RIVER FOREST DEVELOPMENT REVIEW BOARD MEETING AGENDA

- I. Call to Order/Roll Call
- II. Minutes of the May 15, 2025 Development Review Board Meeting
- III. Application #26-0001, Amending Planned Development Ordinance No. 2643 Regarding Priory Park – Application to construct a Splash Pad, expand the south end of the Priory Center, and construct a picnic shelter.
 - a. Discussion Deliberation, and Recommendation
- IV. Approval of the Findings of Fact for Application 26-0001, Priory Park
- V. Public Comment
- VI. Adjournment

Subj: 7354 Division Street – Planned Development Application

Subject: River Forest Park District – Proposed Splash Pad at Priory Park (7354 Division Street)

Splashpad®
View 1

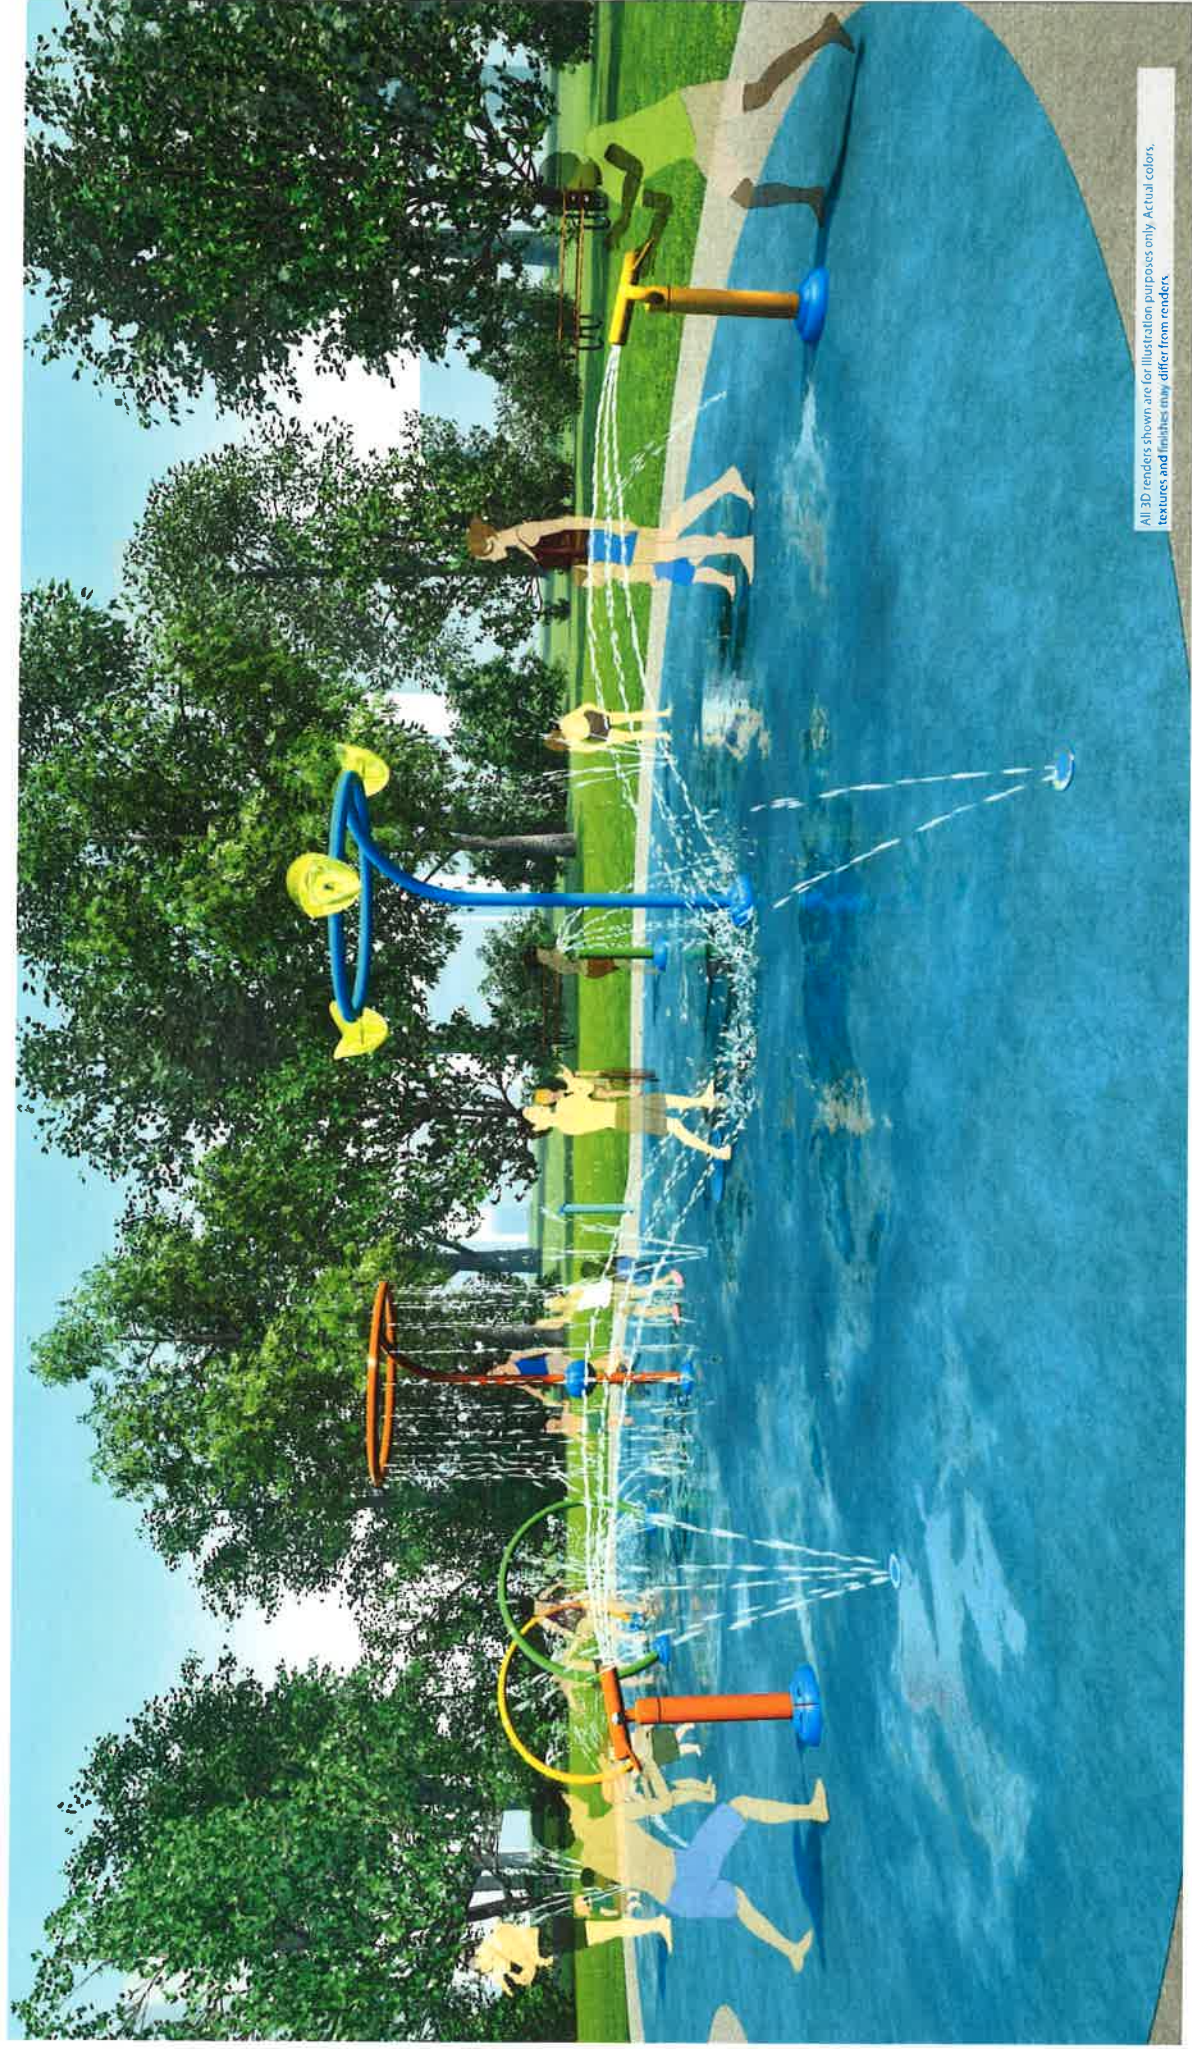
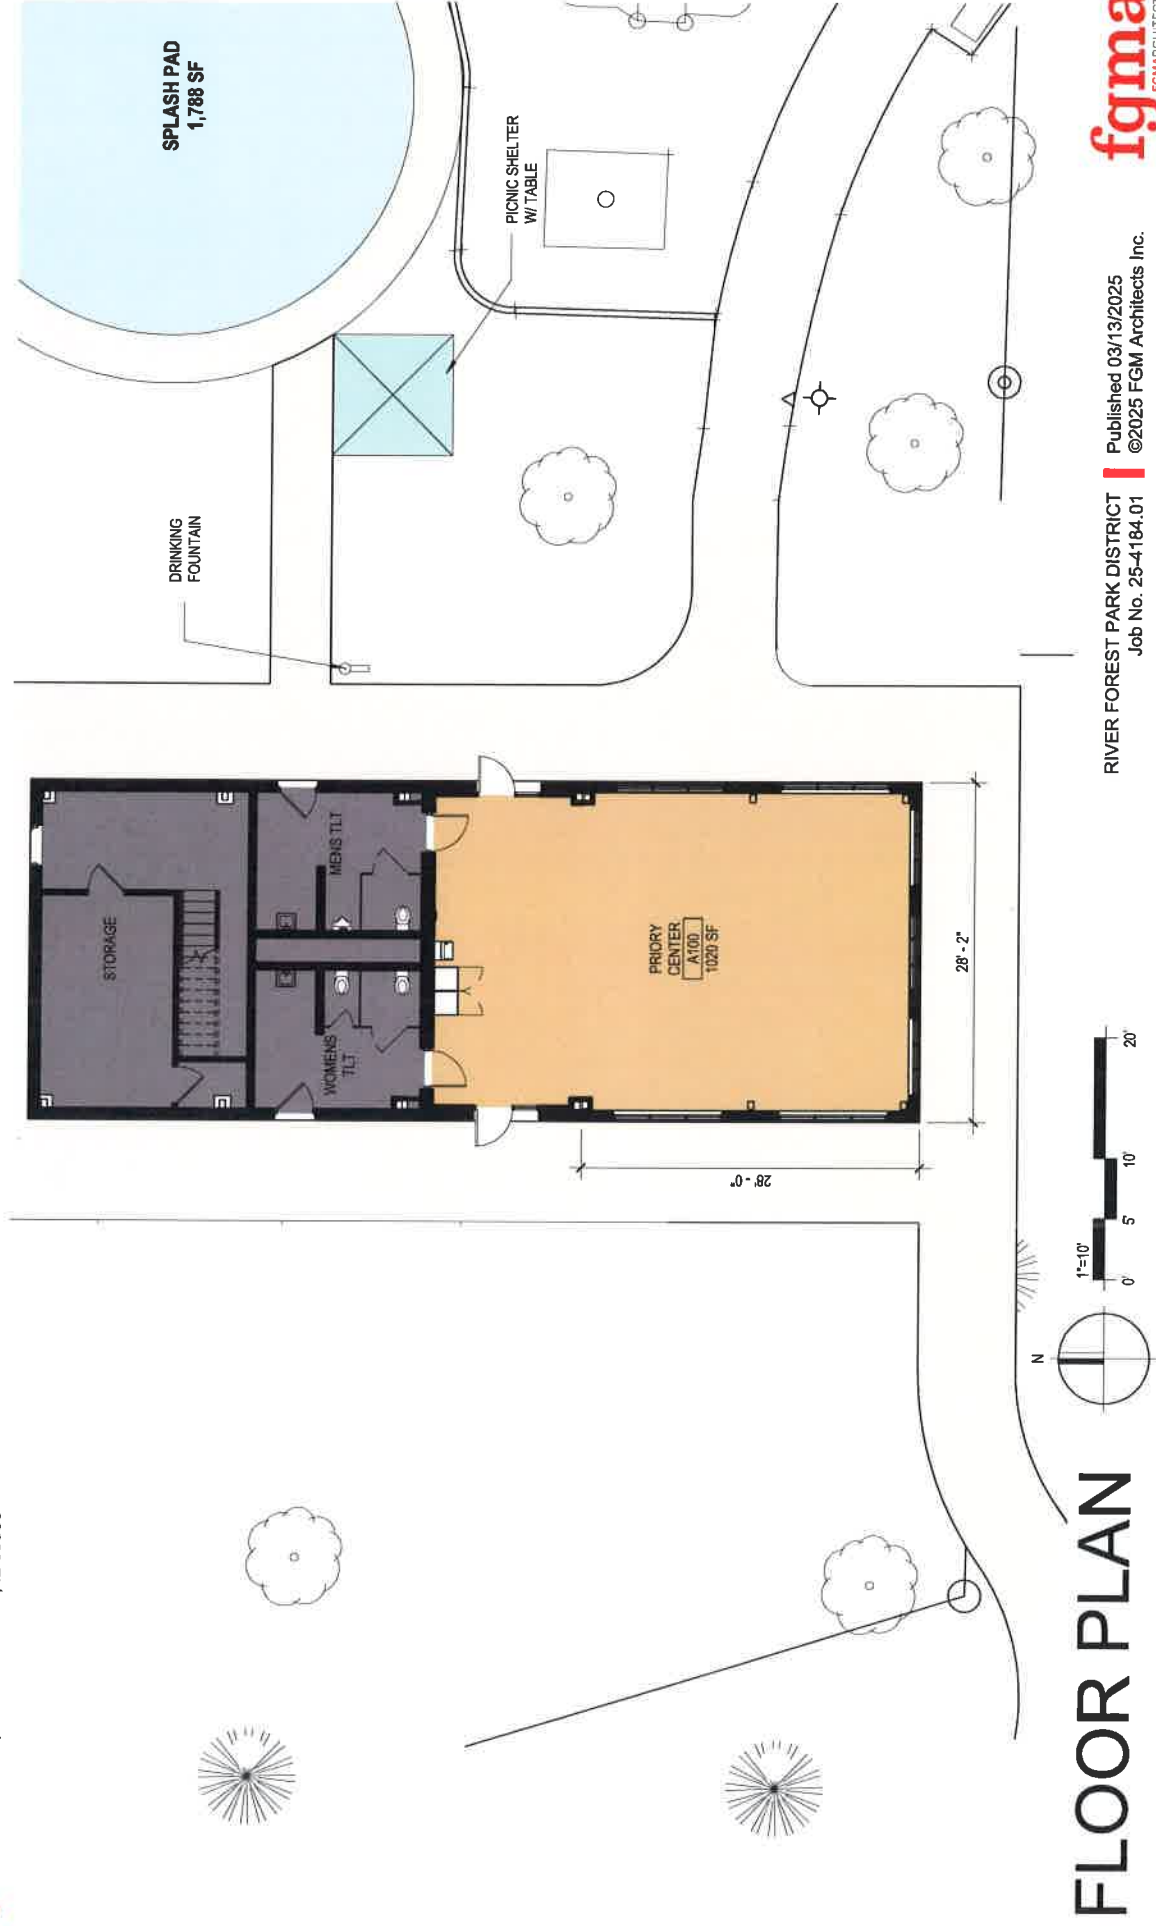
Member Shoemaker asked about how to control the users of the splashpad. Director Sletten said that its expected that users not with this in mind will most likely move along soon enough. Member Davis concurred with Director Sletten.

Member McCole asked about the timing of the splashpad. Director Sletten said they will set the apparatus to rotate the water flow.

Member McCole asked if it was typically a concrete surface or soft? Mr. Nichols responded that the intention of the splash pad was to not store water, so the concrete surface was the better choice. He further explained that there will be a silica sand mixture in the paint to assist with slip risks.

Member Yanaki asked about IDPH recommendations for the splashpad. Mr. Nichols answered that IDPH doesn't have guidelines for the splashpad surface, however they intend to include this silica sand in the paint as this is typically the surface coverage for shallow cement bottom pools.

Director Sletten noted that a more porous surface would allow for bacteria growth and would require significant maintenance. He also stated that he has been in communication with their insurance provider and they prefer the surface from a liability perspective.

Member McCole asked if it would be possible to replace it with rubber if there were a significant number of injuries. Parks President Mike Grant noted that they toured a number of local splash pads in part of their research, and he explained that one park district noted the significant challenges with the soft, porous surface.

EXTERIOR ELEVATIONS

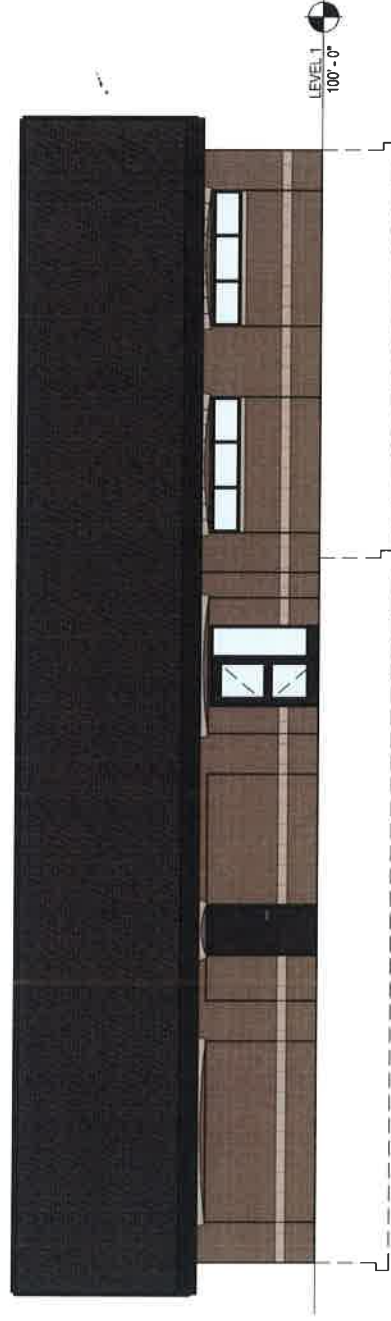
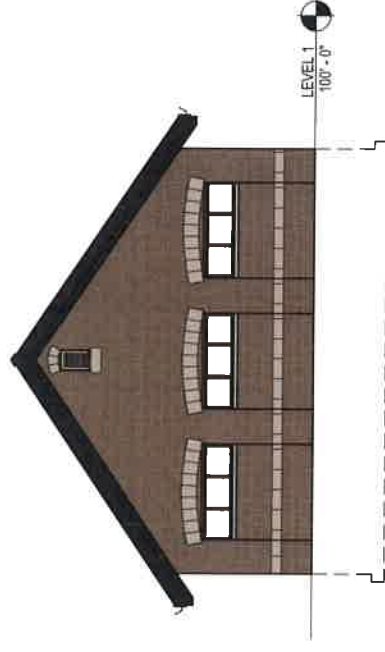
Chairman Cosby asked about the locations of the windows in the structure. Director Sletten said the windows were located up high for the privacy of the users.
